September 23, 2022

RE: 701 Monte Alto Dr NE

> **Grading and Drainage Plan** Engineer's Stamp Date: 09/07/22

Hydrology File: K23D030

ESSRES, LONNIE (BROTZ) - GRADING & DRAINAGE PLAN

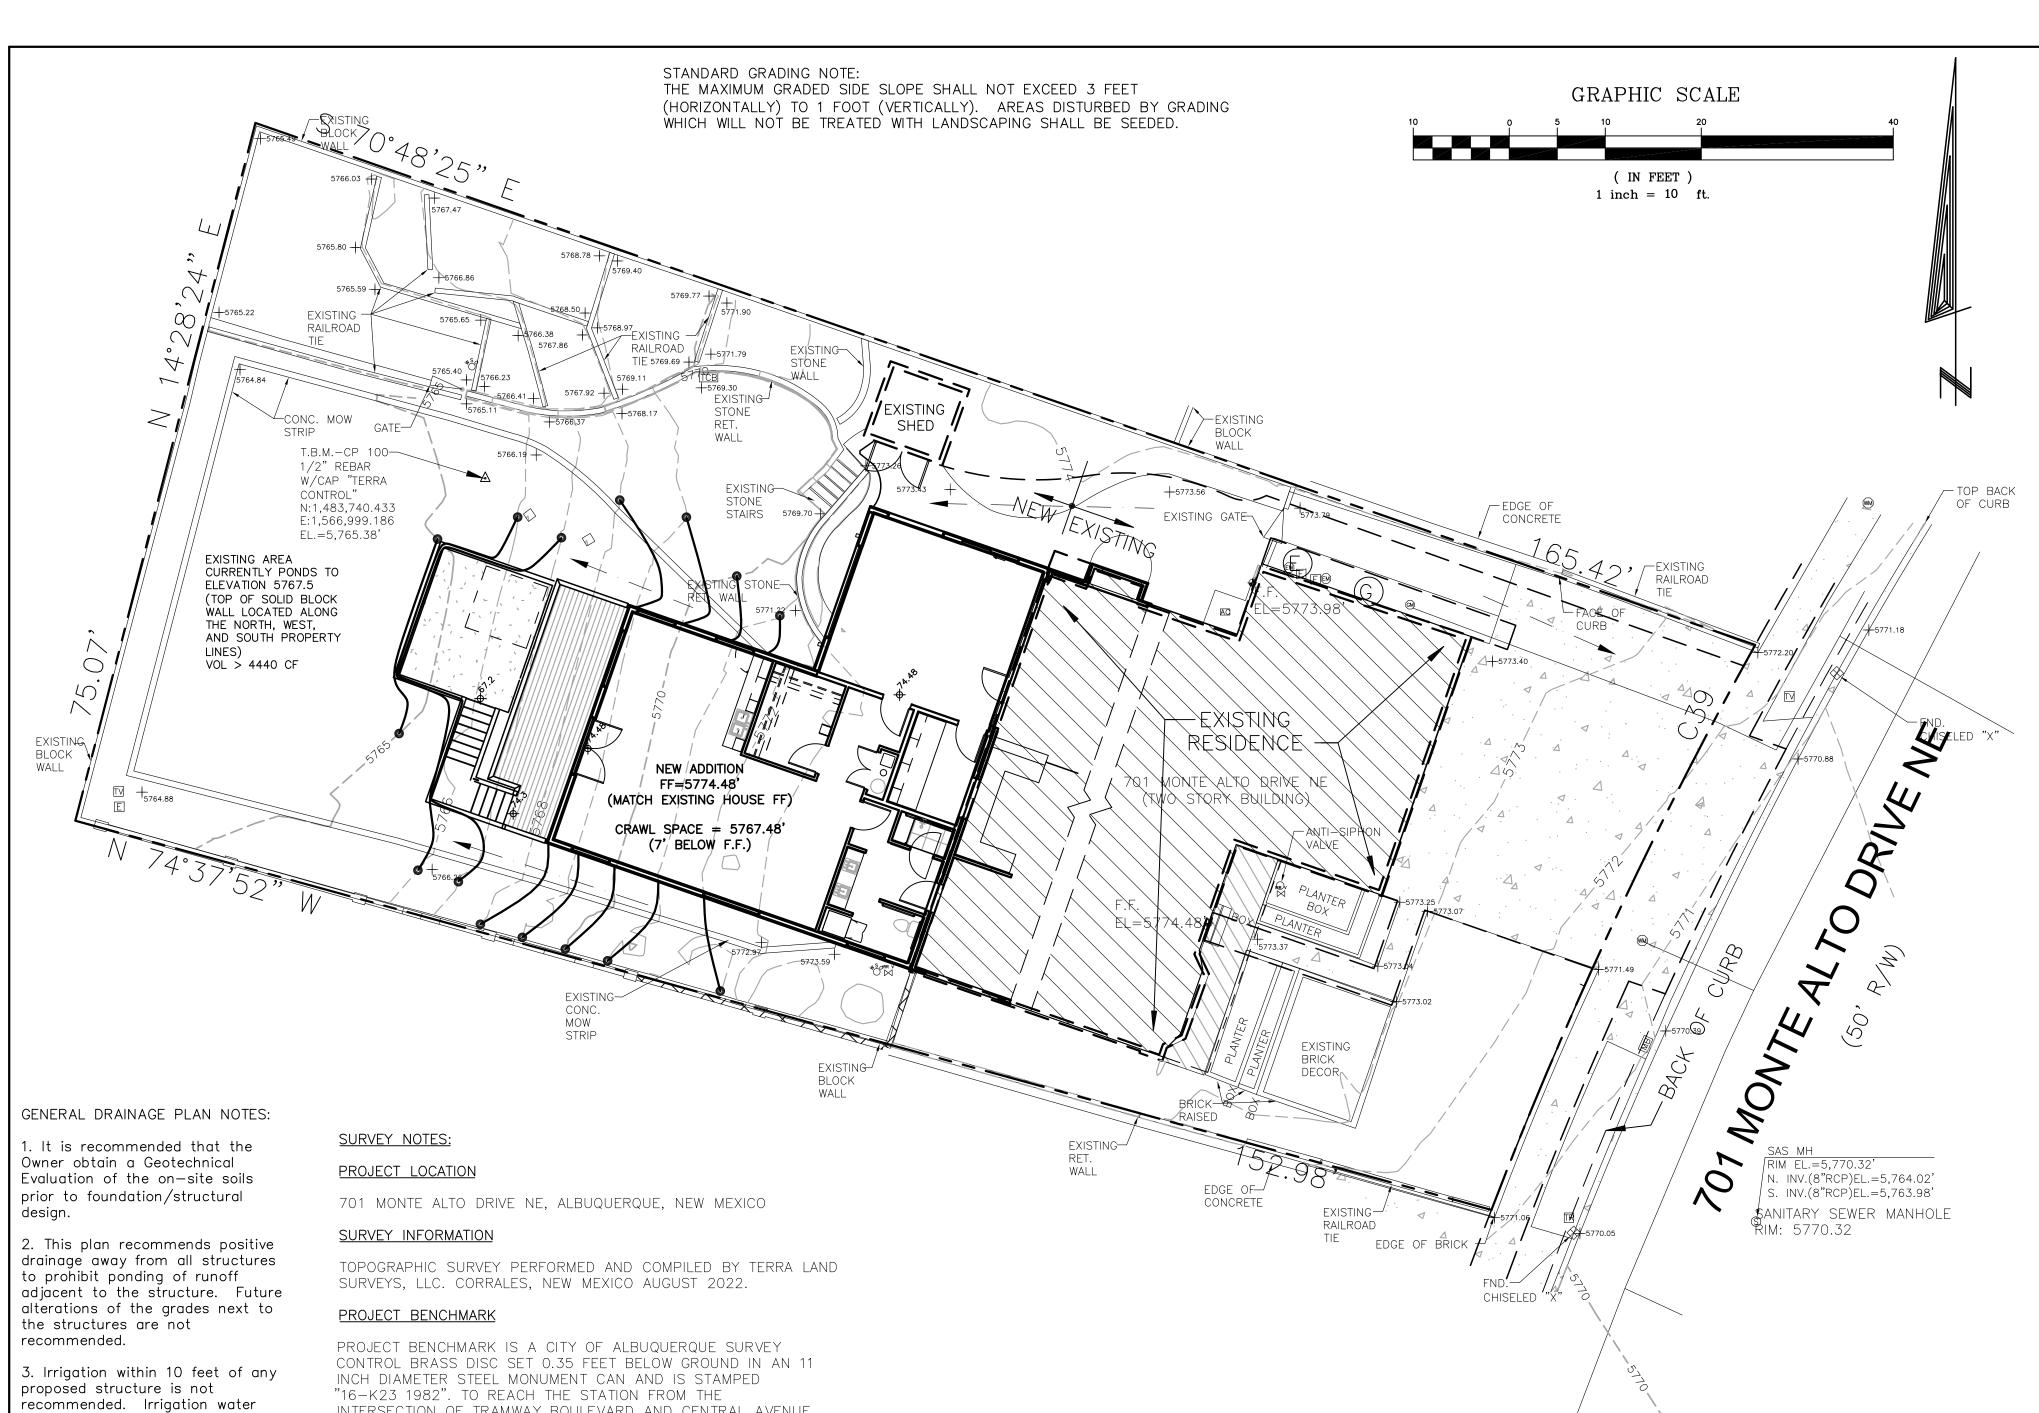
Based upon the information provided in your submittal received 09/07/2022, the Grading and Drainage Plan is approved for Building Permit. Since this project is an addition to an existing house, a Pad Certification is not required for this project. Please attach a copy of this approved plan in the construction sets for Building Permit processing along with a copy of this letter.

1. Engineer's Certification, per the DPM Part 6-14 (G): Engineer's Certification Checklist for Subdivision and Part 6-14 (H): Required Certification Language is required.
